REQUEST FOR COUNCIL ACTION

AGENDA SECTION: PUBLIC HEARINGS	ORIGINATING DEPT: PLANNING	ITEM NO. E-9
ITEM DESCRIPTION: General Development Plan #211 by West 19 th Development to be known as West 19 th Development. The property is located east of 60 th Avenue NW, north of 19 th Street NW and west of Circle 19 Plaza Second Subdivision.		PREPARED BY: Mitzi A. Baker, Senior Planner

GDP 211

RE: General Development Plan #211 by West 19th Development to be known as West 19th Development. The applicant is proposing to develop approximately 90 acres of land with a variety of land uses consisting primarily of low density residential uses. The plan also identifies potential future medium density and non-residential uses. A Zoning District Amendment is being considered concurrent with this application. The property is located east of 60th Avenue NW, north of 19th Street NW and west of Circle 19 Plaza Second Subdivision.

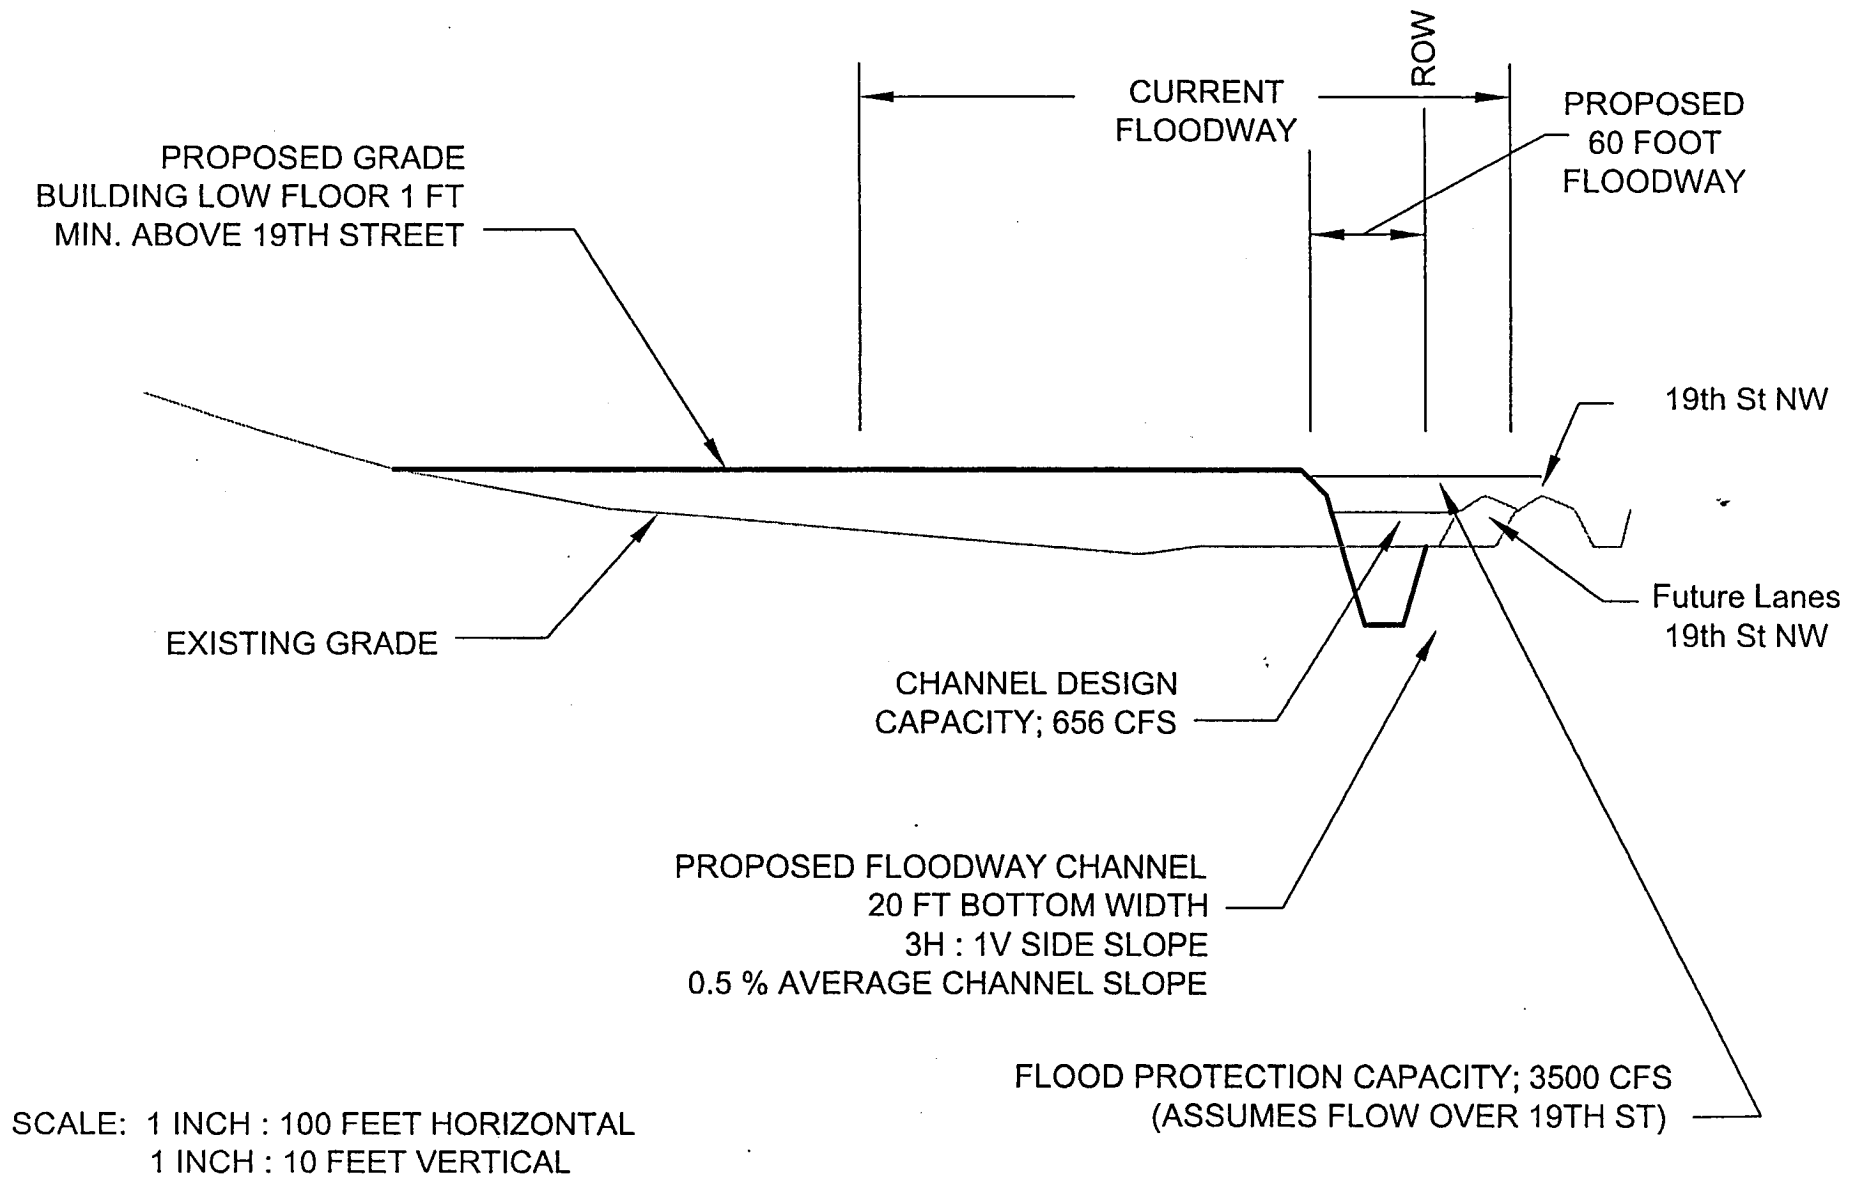
The existing floodway of the NRNF at the West 19th Development is between 200 and 400 feet wide and is shown in Figure 1. The average flow depth is 1.7 feet for the peak 100-year discharge published in the Flood Insurance Study (FEMA, 1998) and less than 0.5 feet for the peak discharge established by the recent CLOMR for this reach. The existing floodway matches the floodway prior to the construction of reservoir KR6. It is our understanding that the regulatory floodway was not changed after the reservoir's construction in order to preserve an area as a measure of safety in the event of a catastrophic breach of the reservoir. Therefore, the existing floodway was based on the peak 100-year discharge rate prior to construction of reservoir KR6 (1,280 cfs).

The proposed floodway channel within the West 19th Development is approximately 60 feet wide and is shown in Figure 1. Figure 2 shows a cross-sectional sketch of the proposed flood control channel and floodway modification. The channel construction would involve both excavation and fill placement. Fill placement adjacent to the channel would elevate the adjacent building pads.

FIGURE 2
PROPOSED CHANNEL
WEST 19TH STREET, ROCHESTER, MN

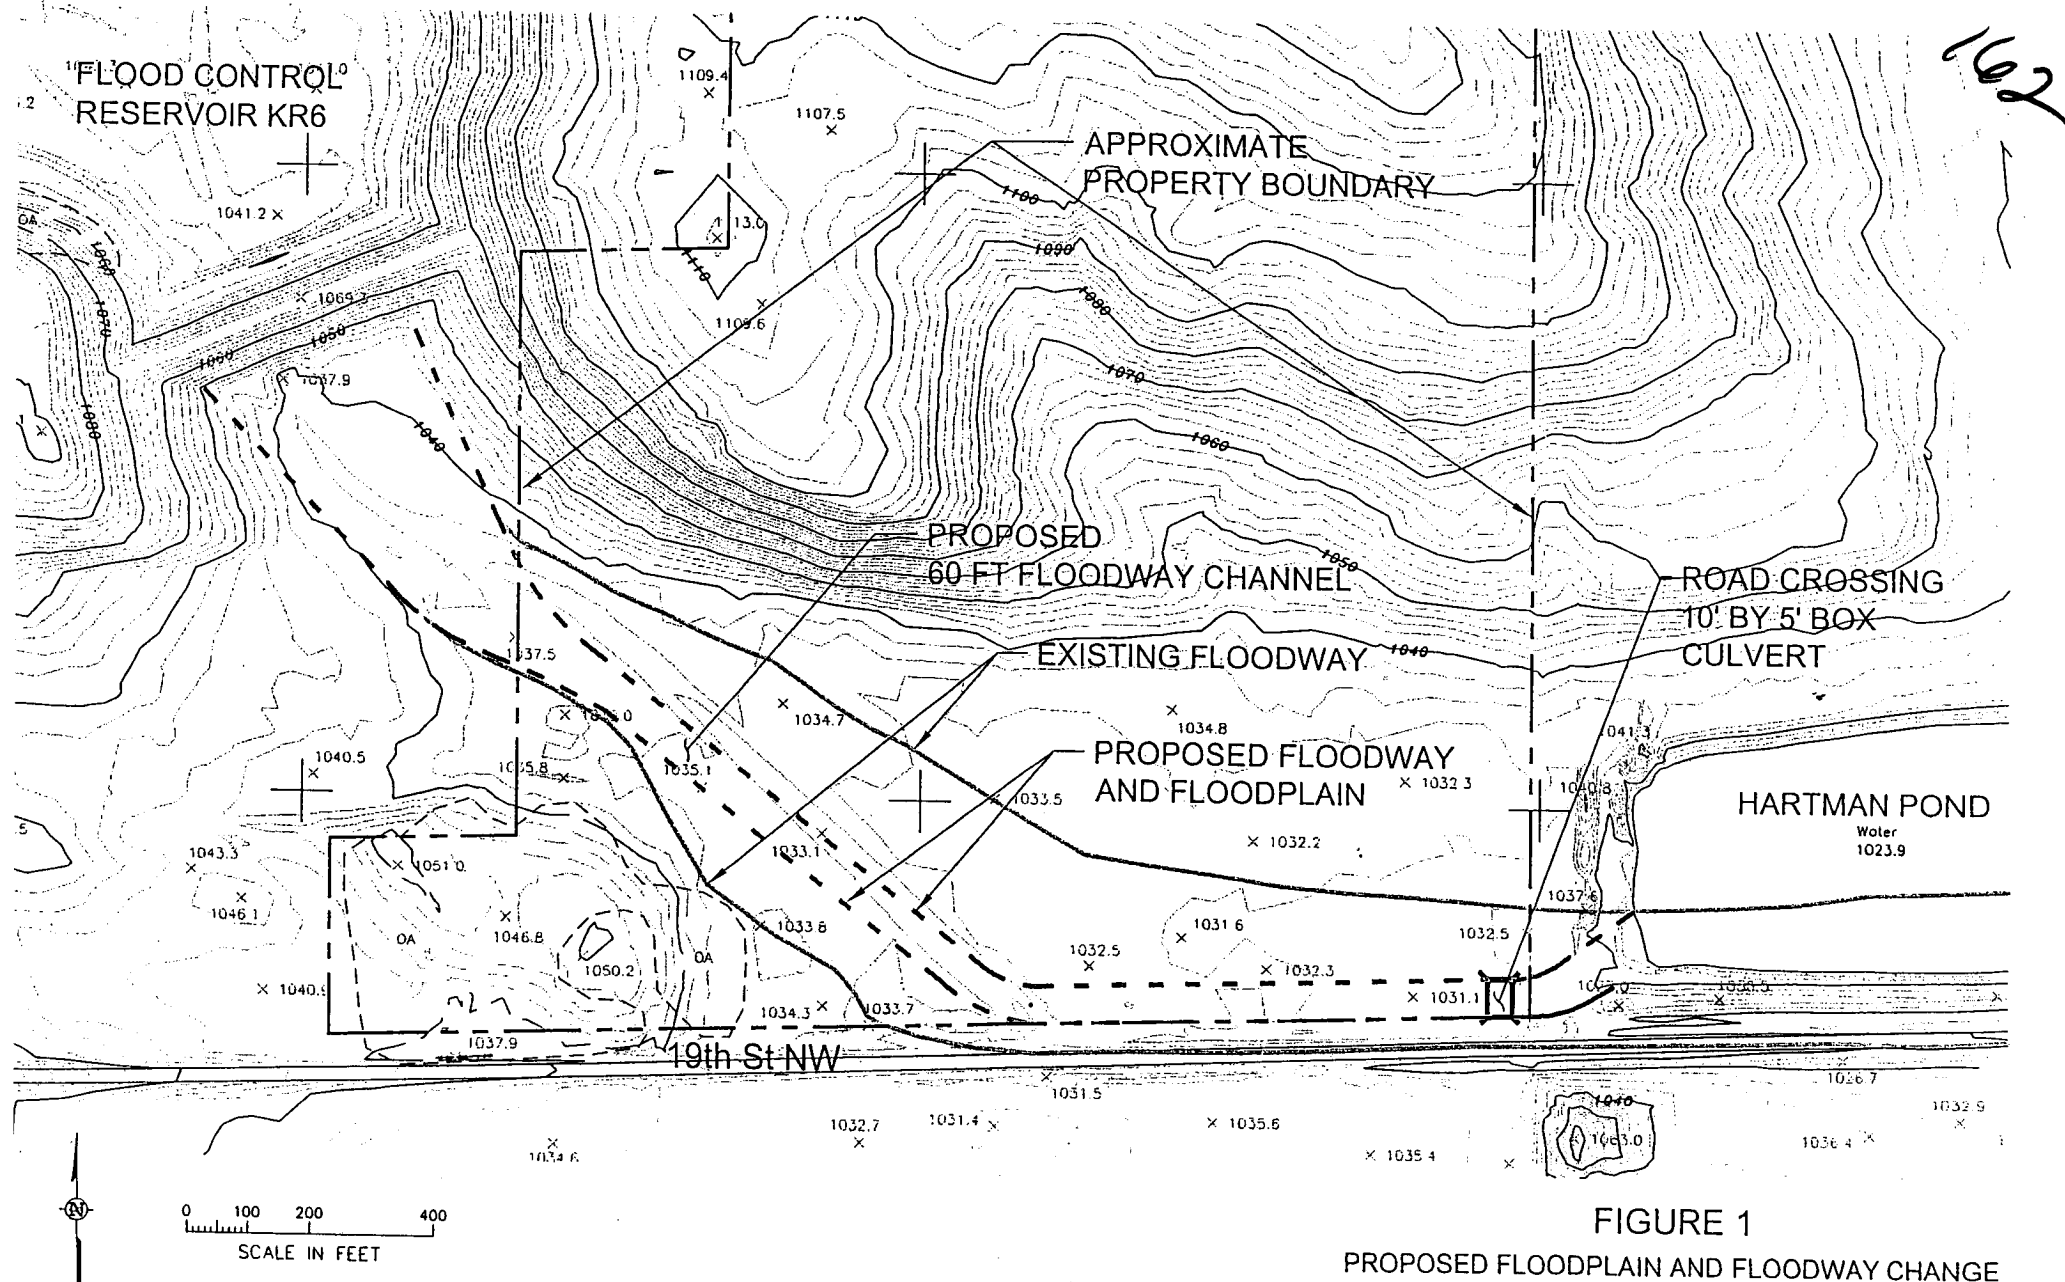
The access road to the site would require a 10' x 5' box culvert. The proposed channel and box culvert were designed using the HEC-2 model for this reach and were designed to pass the design flow without overtopping of 19th Street NW. A FEMA floodplain map revision will be necessary to revise the proposed floodway and allow fill placement.
